To: Urban Design Committee  
From: Planning and Preservation Division  
Date: August 20, 2015  
RE: **Conceptual Location, Character and Extent Review of the Greater Richmond Transit Company plans for a Bus Rapid Transit system along Broad Street, N. N. 14th Street and E. Main Street from the intersection of W. Broad Street and Staples Mill Road on the west to the intersection of E. Main Street and Orleans Street on the east; UDC No. 2015-19**

The application is for Conceptual Location, Character and Extent Review of the 30% conceptual design of GRTC plans for a Bus Rapid Transit (BRT) system.

Figure 3. Proposed section for Broad Street

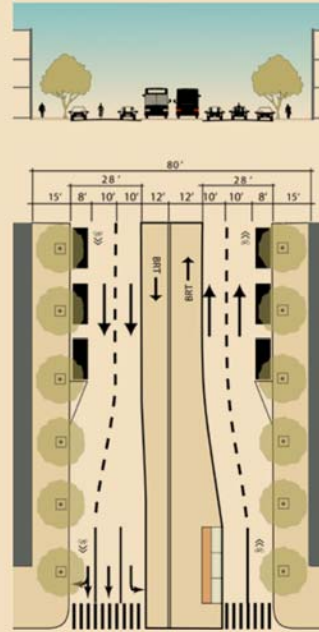
The City's Downtown Plan recommends a median-running BRT (see image on page 12 of this report). There are several benefits to this configuration. For one, the dedicated

lanes can be transitioned into streetcar tracks when federal streetcar funding becomes available, which is advocated for in the Plan. The applicant's report also notes that running the BRT in the center of the roadway helps to minimize conflicts with vehicles turning to/from side streets and private entrances, which addresses a public safety concern, and also allows parallel parking along the curb. In addition, having the two bus lanes located in the center of the roadway helps to enhance the look and feel of a dedicated transitway. One design principle that has been consistent through the corridor is that two general purpose through lanes be maintained in each direction on Broad Street with any proposed transit configuration. It is important at this phase of the planning of the BRT system to better understand why a median-running operation was not chosen for the section from N. Foushee Street to N. 9<sup>th</sup> Street and what potential impacts that may carry for plans for a future light-rail system.

- That the BRT planning team investigates utilizing a median-running operation from N. Foushee Street to N. 9<sup>th</sup> Street and what potential impacts not doing so would have on plans for a future light-rail system, fully recognizing the need for two general purpose lanes and the addition of left turn lanes and local transit stops as needed.
